Service Bulletin

Bulletin No.: PI1312

Subject: A/C Compressor and A/C Pipe Assembly Changes

Models: 2015 Chevrolet Equinox (Built Prior to VIN Breakpoint F6126358)
2015 GMC Terrain (Built Prior to VIN Breakpoint F6127049)
Equipped with 3.6L Engine (RPO LFX)

2010-2014 Model Year A/C Compressor and Pipe Assembly Design

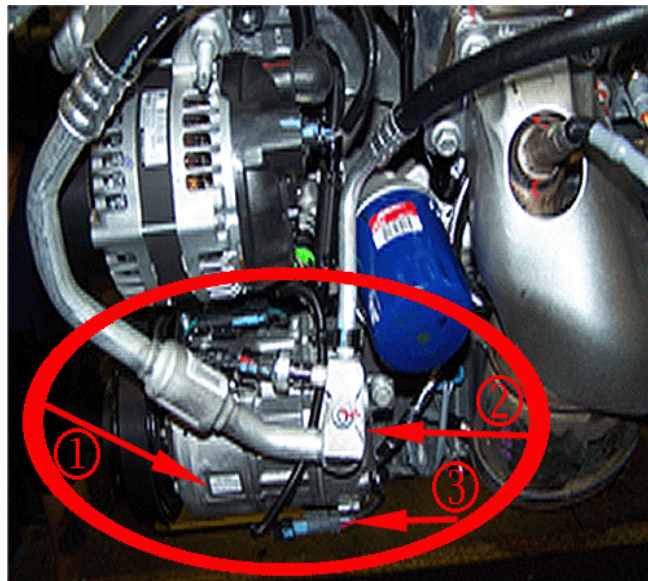
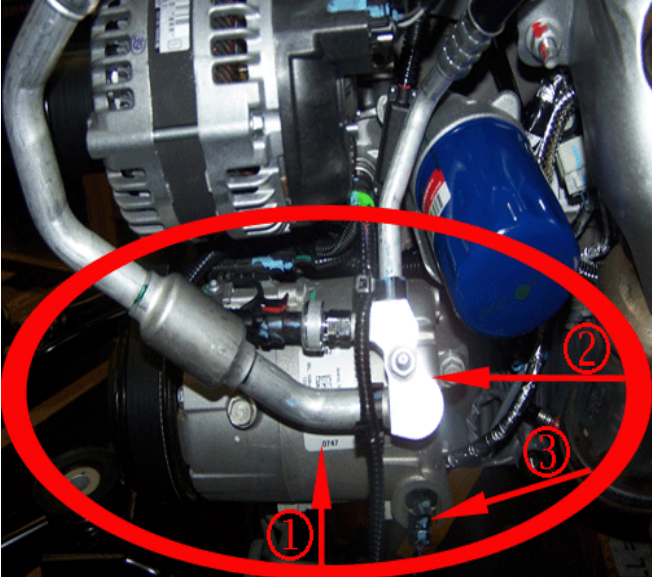
The purpose of this PI is to inform dealership personnel and technicians of a design and supplier change with the A/C compressor. Please use the following information below to identify the design changes.

The 2010-2014 A/C compressor and pipe assembly design will have a smaller label on the compressor located near the pulley (1). The location where the A/C pipe housing mounts to the compressor is rectangular (2) and the connector bracket for the compressor harness is horizontal and located on the bottom rear of the compressor (3).

The design changes made for the 2015 model year A/C compressor and pipe assembly consist of a larger label located in the middle of the compressor (1). The A/C pipe housing has a different shape (2) and the connector for the compressor is mounted vertically (3).
